Plymouth-area power grid upgrades

Frequently Asked Questions from comments received

Figure 4.2

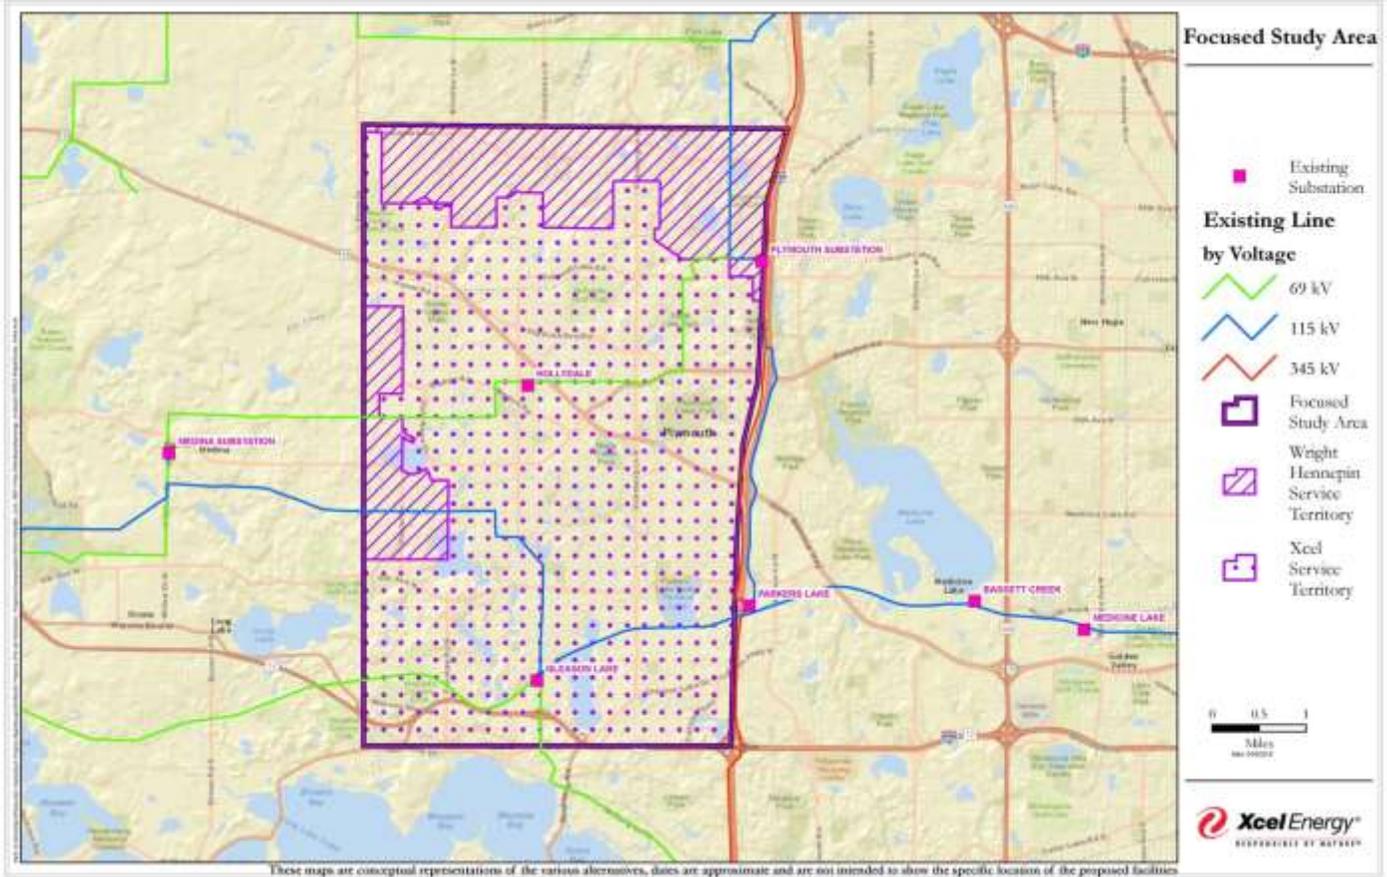
8. What area of Plymouth would benefit electrically from Alternative A and B?

44. Please explain why each of the proposed alternatives impacts neighborhoods other than those in western Plymouth that Xcel Energy believes have the current need for additional power, including the production of all related documents?

4. ***An explanation of why the impacted homes from proposed routes A and C should be asked to shoulder the burden the for power generated to western Plymouth, including an explanation and all related documents that discuss whether any viable transmission and/or substation options exist in the Transmission Area of Concern as that term is defined in the Engineering Report:***

- a. See section 8.0 of the Electrical System Assessment posted on the project website.
- 54. The posted Xcel report identifies the Transmission Area of Concern but does not adequately explain why distribution and substation upgrades and modification cannot be made within this area versus impacting communities outside of the Transmission Area of Concern;**

- a. See Focused Study Area in figure 4.2 and the Transmission Area of Concern in 4.3 referenced in Question 2.
- b. All three Alternatives benefit the same area in Plymouth.

- a. The three proposed alternatives are intended to meet both the distribution and transmission needs of the Plymouth area. The area in need of distribution improvements is the Focused Study Area, depicted on page 13 (Figure 4.2) of the Electrical System Assessment. The demand for power within this 24-square mile area currently exceeds the capabilities of the existing electrical distribution facilities. In addition, there is a need on the transmission system to alleviate low voltage conditions on the transmission system serving the transmission area of concern. The transmission area of concern is depicted in Figure 4.3 on page 16 of the Electric System Assessment. The proposed infrastructure improvements proposed by Xcel Energy in these three alternatives are designed to address both the distribution and transmission needs in these two areas of concern.

- a. See FAQ 2. The three proposed alternatives are intended to meet both the distribution and transmission needs of the Plymouth area. The area in need of distribution improvements is the Focused Study Area, depicted on page 13 (Figure 4.2) of the Electrical System Assessment. The demand for power within this 24-square mile area currently exceeds the capabilities of the existing electrical distribution facilities. In addition, there is a need on the transmission system to alleviate low voltage conditions on the transmission system serving the Transmission Area of Concern. The Transmission Area of Concern is depicted in (Figure 4.3) on page 16 of the Electric System Assessment. The infrastructure improvements proposed by Xcel Energy in these three alternatives are designed to address both the distribution and transmission needs in these two areas of concern. (figures above)

- a. See FAQ 2. The three proposed alternatives are intended to meet both the distribution and transmission needs of the Plymouth area. The area in need of distribution improvements is the Focused Study Area, depicted on page 13 (Figure 4.2) of the Electrical System Assessment. The demand for power within this 24-square mile area currently exceeds the capabilities of the existing electrical distribution facilities. In addition, there is a need on the transmission system to alleviate low voltage conditions on the transmission system serving the Transmission Area of Concern. The Transmission Area of Concern is depicted in (Figure 4.3) on page 16 of the Electric System Assessment. The infrastructure improvements proposed by Xcel Energy in these three alternatives are designed to address both the distribution and transmission needs in these two areas of concern.

Figure 4.3

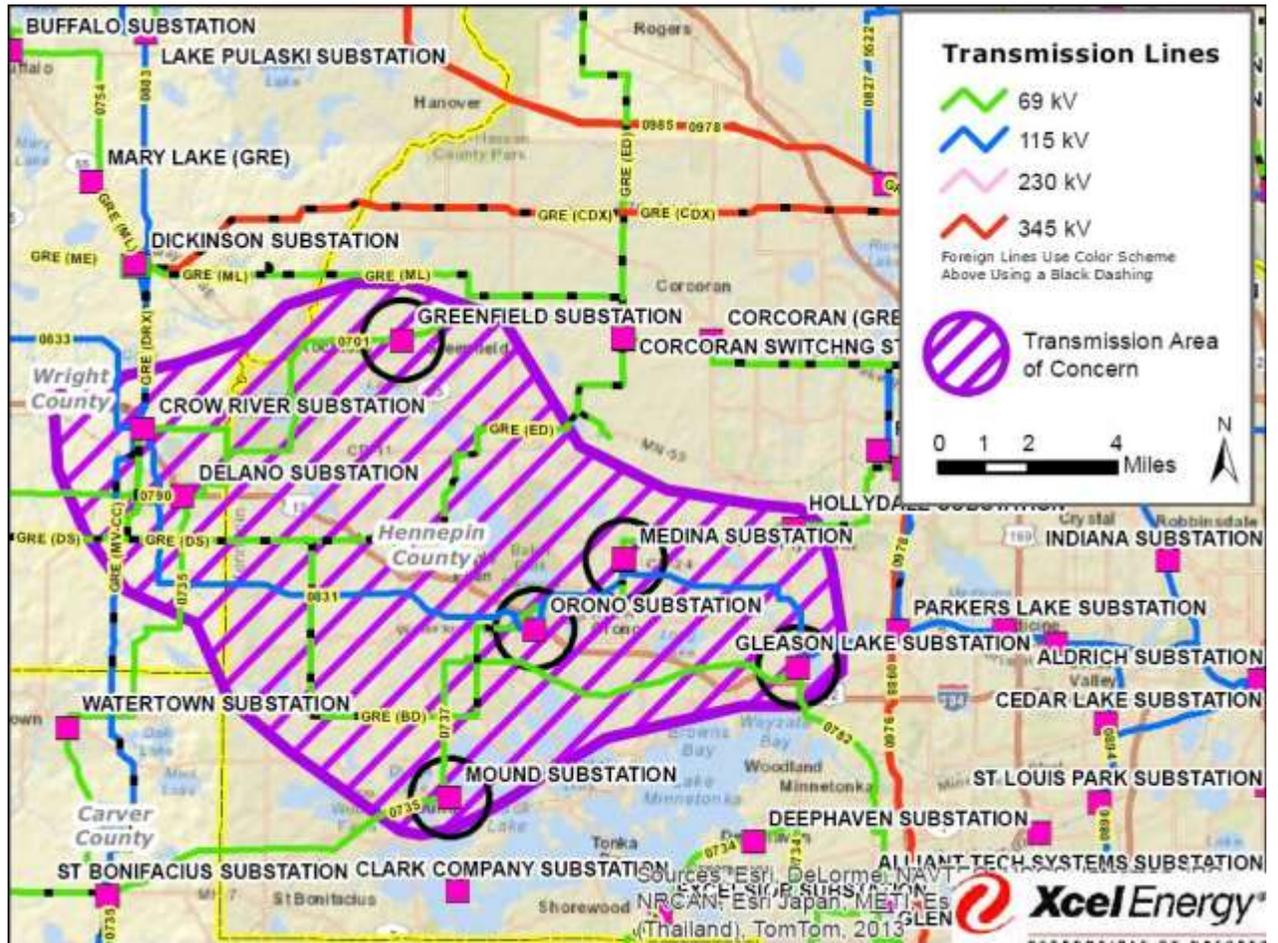
9. What area of Plymouth would benefit electrically by Alternative C?

- a. See Focused Study Area in figure 4.2 and the Transmission Area of Concern in figure 4.3 referenced in Question 2.
- b. All three Alternatives benefit the same area in Plymouth.
